SIGHT INSPECTION REPORT

Count 2

Exhibit No. 10
Case No(s) MC-2005-0028
Date 3-02-05 Rptr XF

Case No. MC-2005-0028

Count II Sassman Item 12 damaged beam

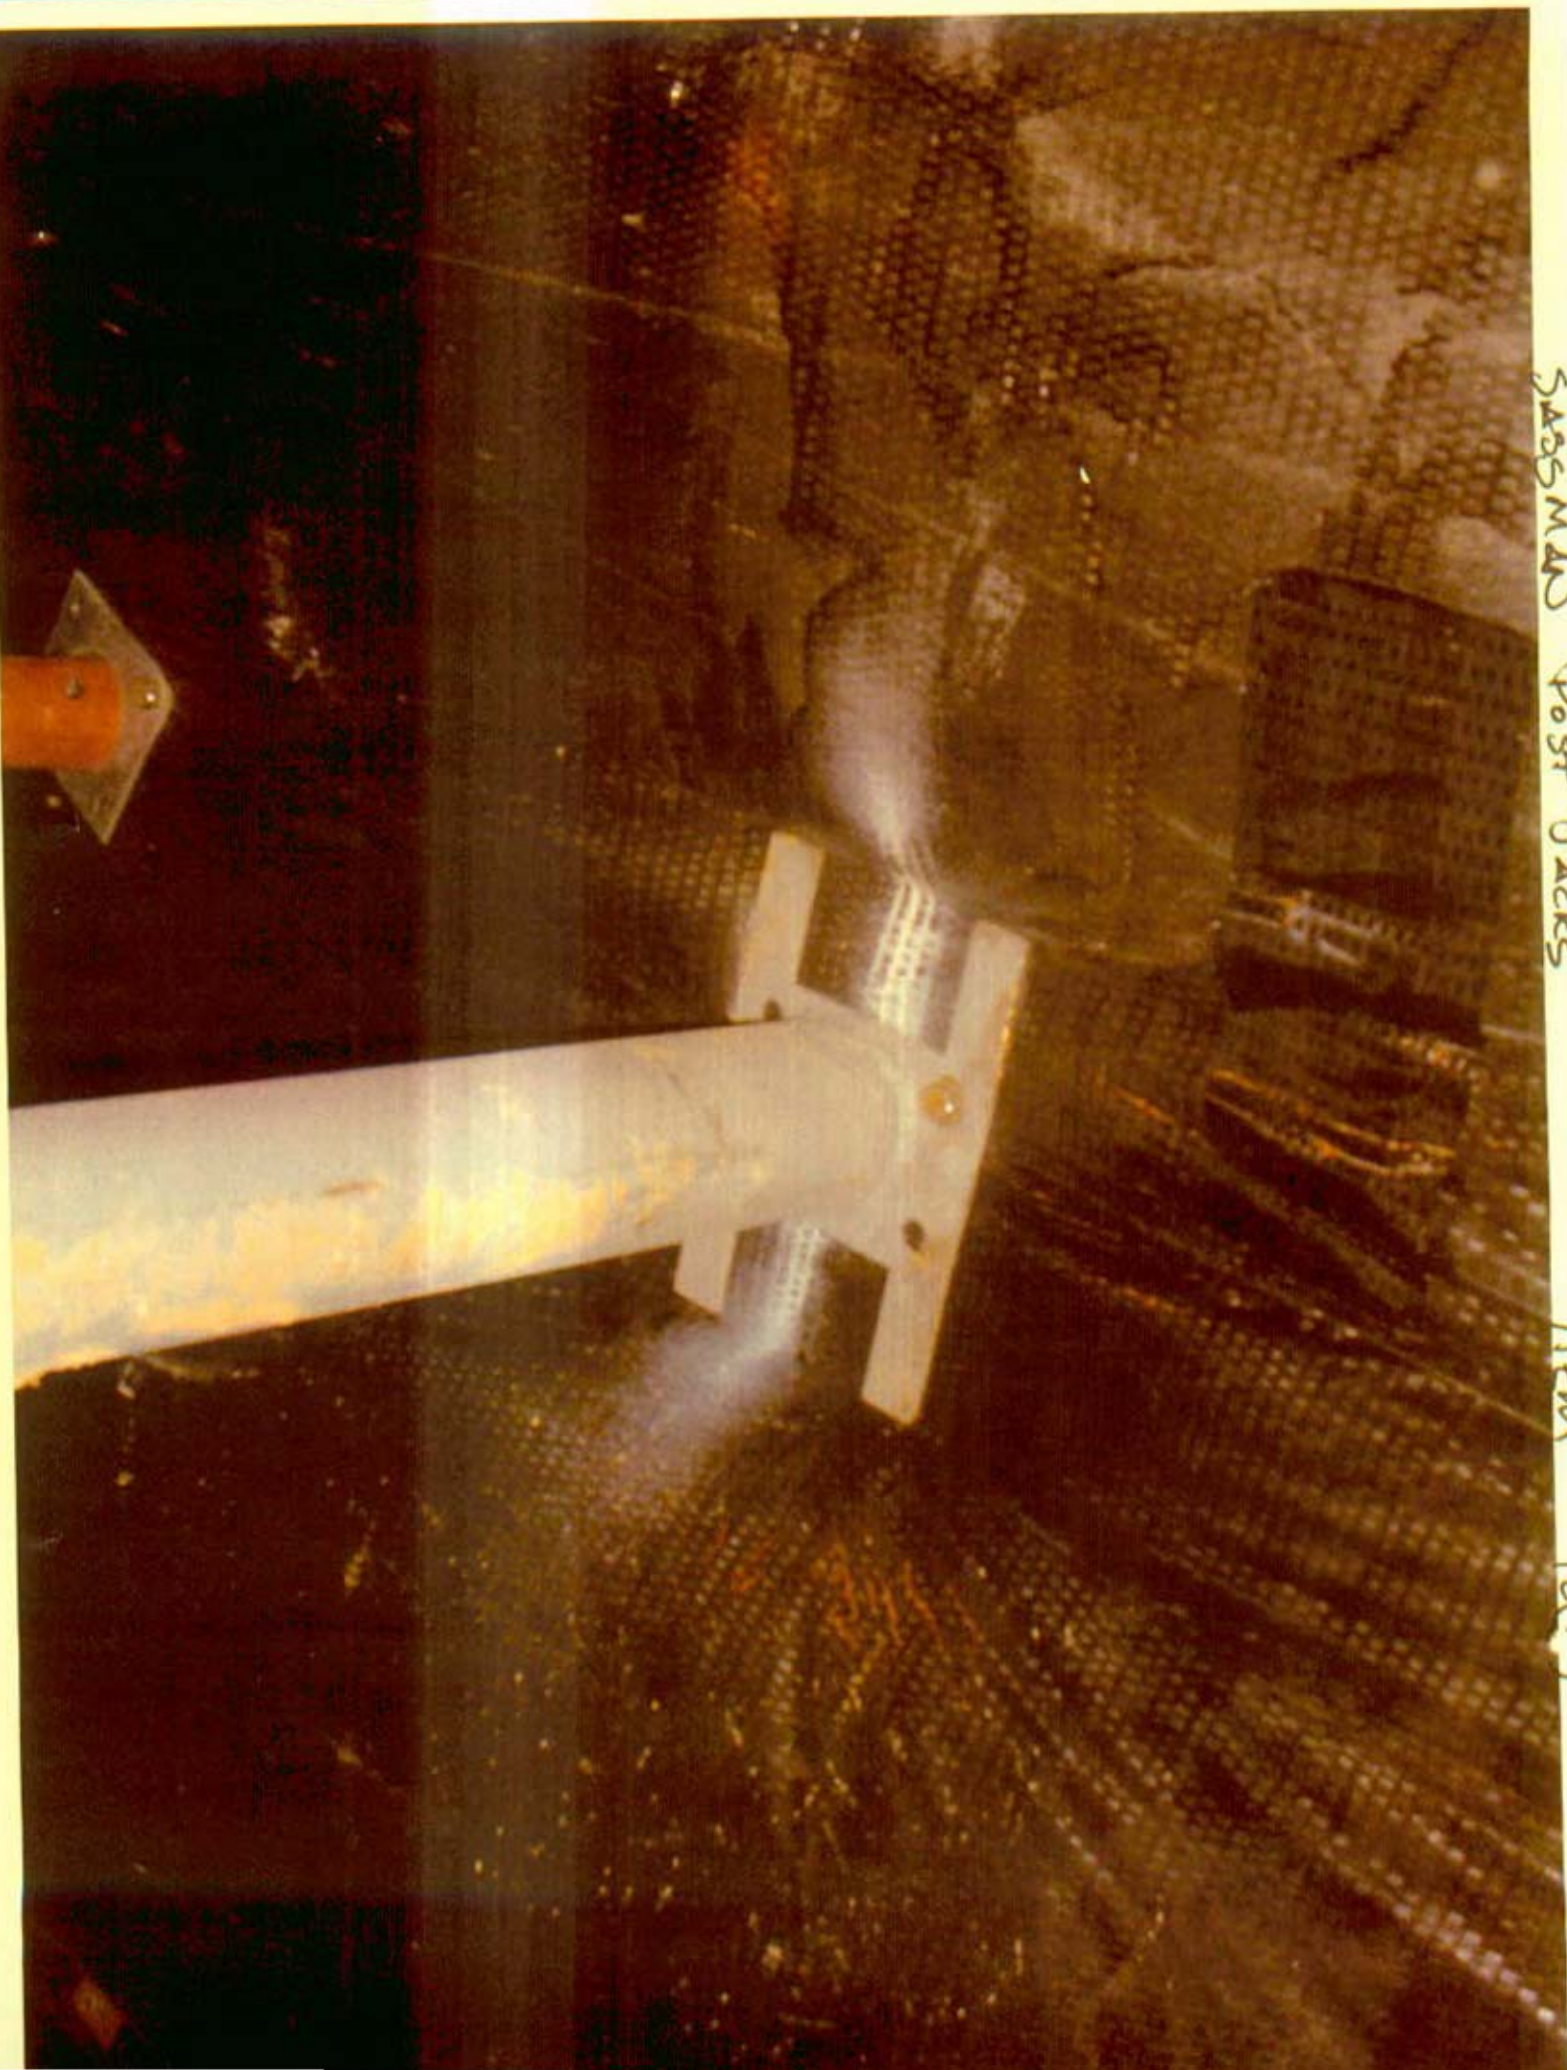
- 12) Both of the main I-beams under the front section have been damaged. The I-beams are damaged just behind the axle area of the home. Approximately 5 feet of the beams are bent in the flange and web of the beams and the beams are laying over. The dealer must submit an application for permission to alter along with the required documents to the Director for approval. The frame repairs must be made according to the manufactures approved design.
~~Incomplete 5/11/04~~ Incomplete 1/14/05, See image H,I,J,K,L

It will, however, be necessary to install steel shims as required to provide a weldment at the intersection of these two beams and the crossbeam that supports them to ensure stability in the case of a lateral event such as extremely high wind conditions or an earthquake. Local straightening of the bottom flange and the local web may be necessary to provide the welds, but it must be done, and must be done without heating them, because the camber and temper would be lost in these members, which is not acceptable. Provide a minimum of 1" of 1/8" fillet weld on each side of both of these intersections. The Client should call Strain Engineering immediately if there are questions regarding this operation or problems in the field.

We have obtained the Structural engineers report and would like to make the recommended repair to the beam under the home. The repair should take about 45 minutes to repair . The structural engineer states that just to shim and make an 1" weld on the beams will secure the home.

ITEM 10(F)

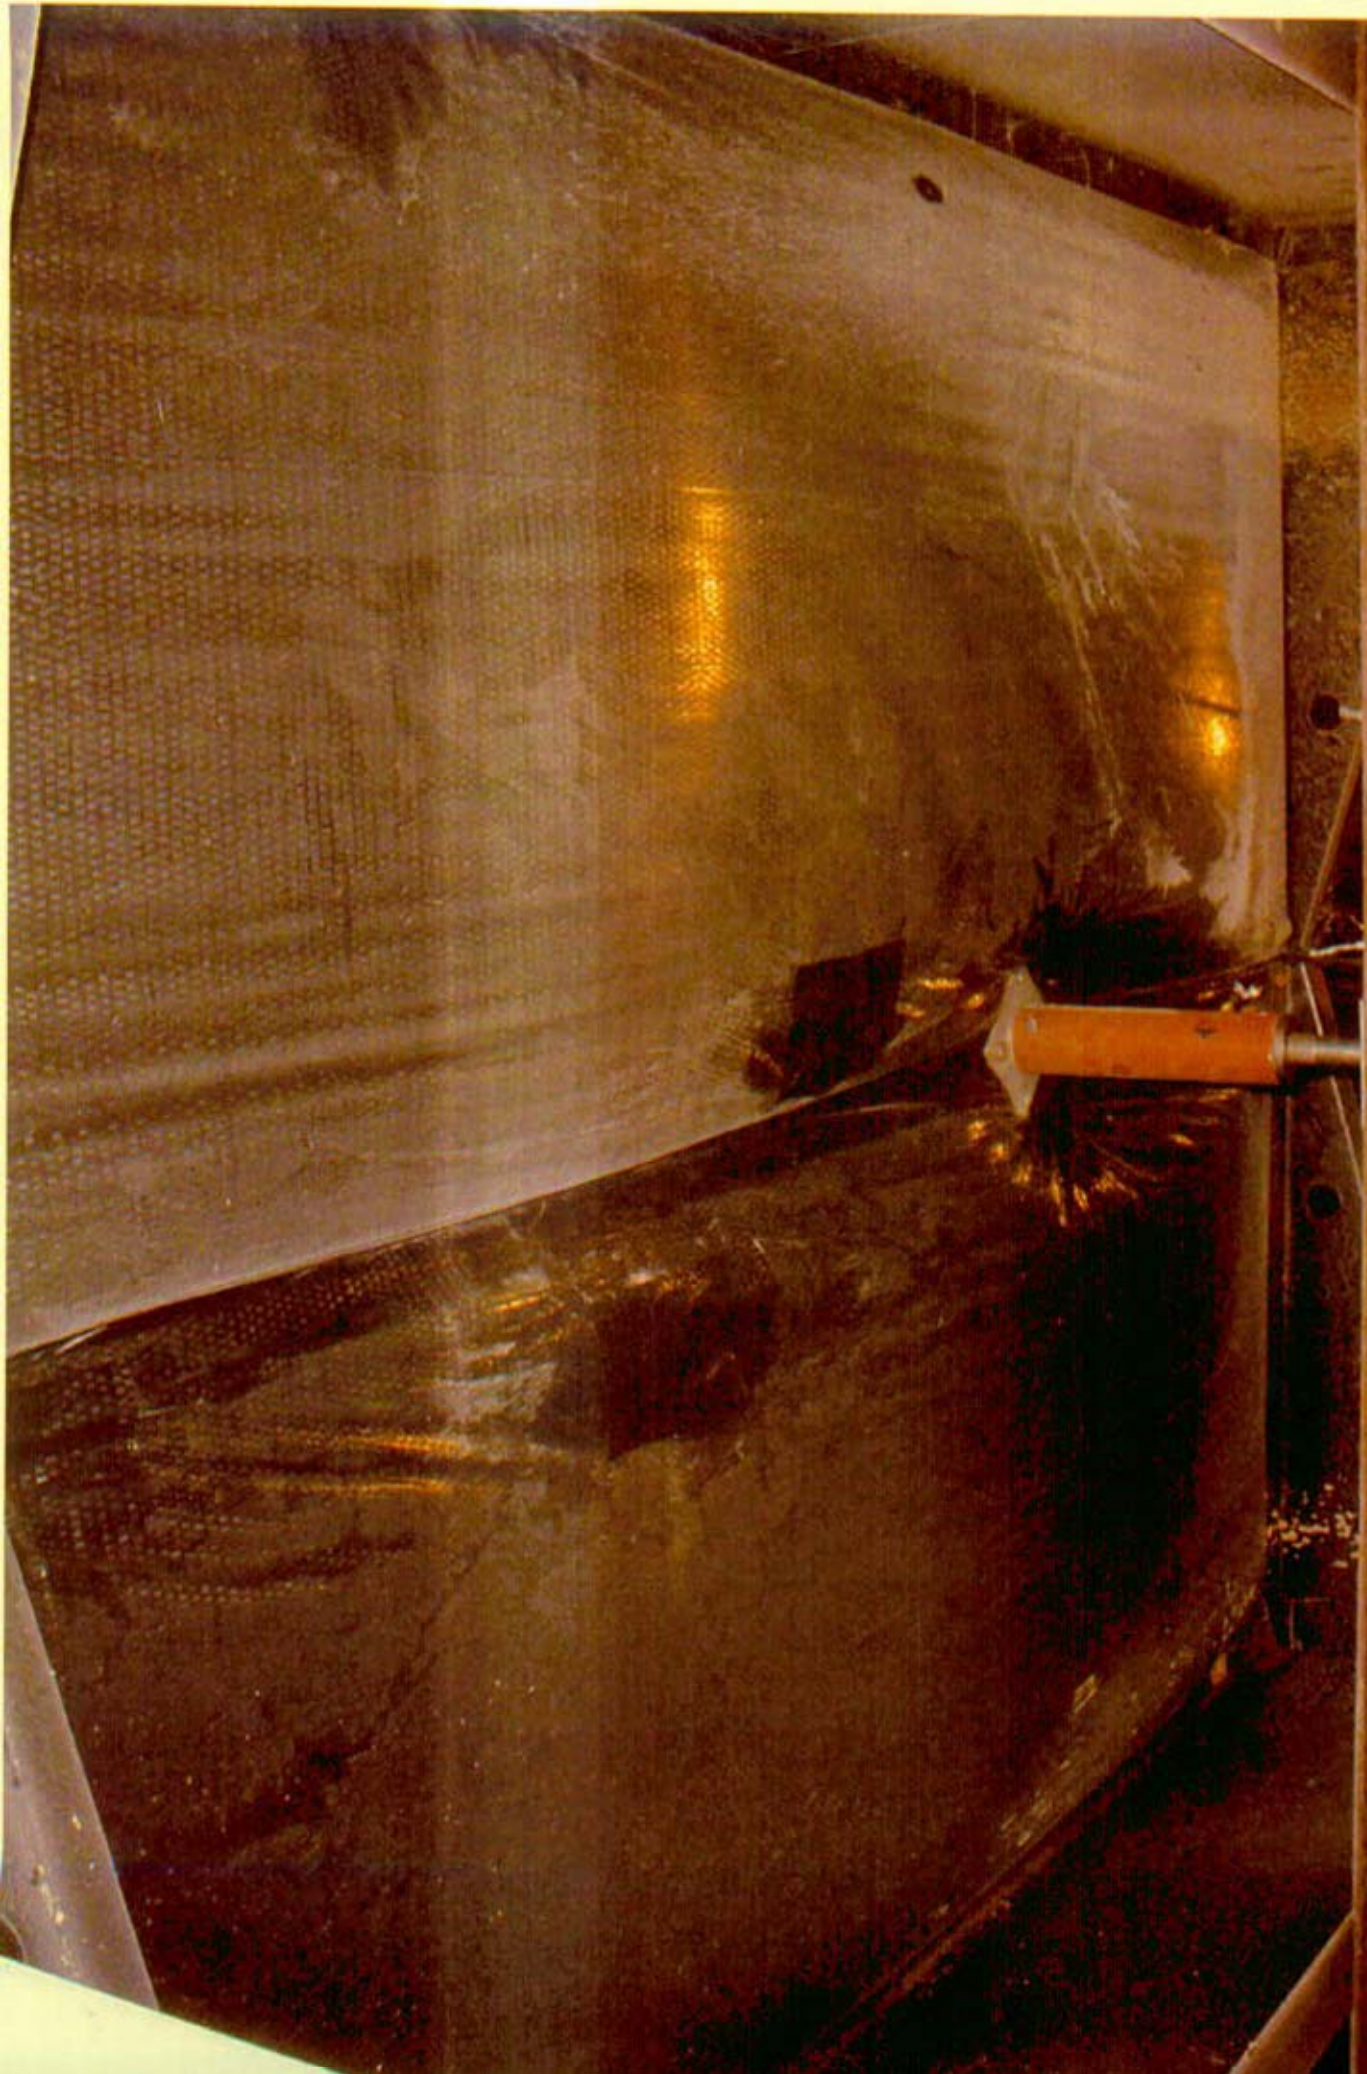
- f) The bottom board needs to be patched along the centerline at the lag bolt locations.
~~Incomplete 5/11/04~~ Incomplete 1/14/05, See image F
 - g) The combustion air inlet for the fireplace must be vented to the exterior of the basement foundation.
~~Incomplete 5/11/04~~ Incomplete 1/14/05, Note: The combustion inlet pipe has been extended to the exterior of the foundation but has been reduced from 6" pipe to 4" pipe and the joints are sealed with duct tape. See image G

I have been to this home over a dozen times to fix items on the public service commission list as well as other items that were not on the list. The items I corrected are as follows
Items 10 b the column support which we tried to install atleast 5 different times , but the customer kept changing her mind as to if she really wanted them or not. c) the crossover wire have been re covered and installed in the under belly of the home. d) the ground wire has been installed even though the home is welded dow to 8" steel beams. E) it is noted in the report the customer says she installed the straps I installed them. f) The bottm board has been pathced. Please turn over
